THOMPSON PARK LOT 2

Mecklenburg County
Health Department

RE: Property located at Avinger Dr.
FILE: 6359A
PARCEL: 00703120

MECKLENBURG COUNTY HEALTH DEPARTMENT
SITE EVALUATION REPORT
SERIAL NUMBER 16616

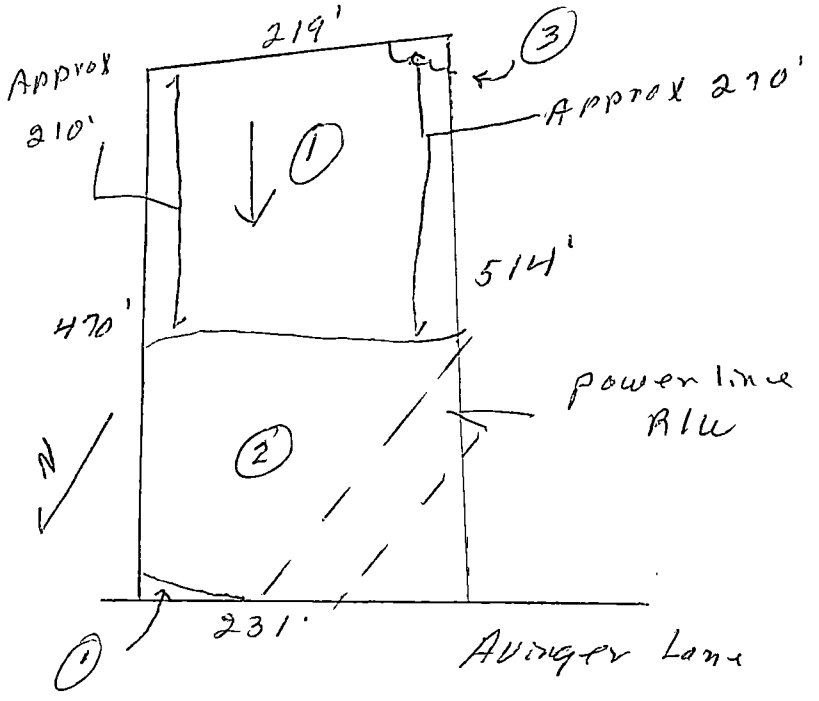
Comments: Will need 100% repair - System may need lift pump

FACTORS	AREA 1	AREA 2	AREA 3	AREA 4	AREA 5	AREA 6
Topography	(S) PS U 6-10%	S PS (U) Drainageway Depression	S PS (U) complex slope	S PS U	S PS U	S PS U
Texture	S (PS) U Clay	S PS U —	S PS U	S PS U	S PS U	S PS U
Structure	S (PS) U Blocky	S PS U —	S PS U —	S PS U	S PS U	S PS U
Drainage	S (PS) U 7-36" TO WATER	S PS U —	S PS U —	S PS U	S PS U	S PS U
Depth	S (PS) U >36"	S PS U —	S PS U —	S PS U	S PS U	S PS U
Restrictive Horizons	S (PS) U 7-36"	S PS U —	S PS U —	S PS U	S PS U	S PS U
Available Space	S (PS) U	S PS U —	S PS U	S PS U	S PS U	S PS U
Other (specify)	S PS U	S PS U	S PS U	S PS U	S PS U	S PS U
Soil Group/Series	IVA Enon-Lilly	Drainageway Depression	Complex Slope			
Area Classification	S (PS) U	S PS (U)	S PS (U)	S PS U	S PS U	S PS U
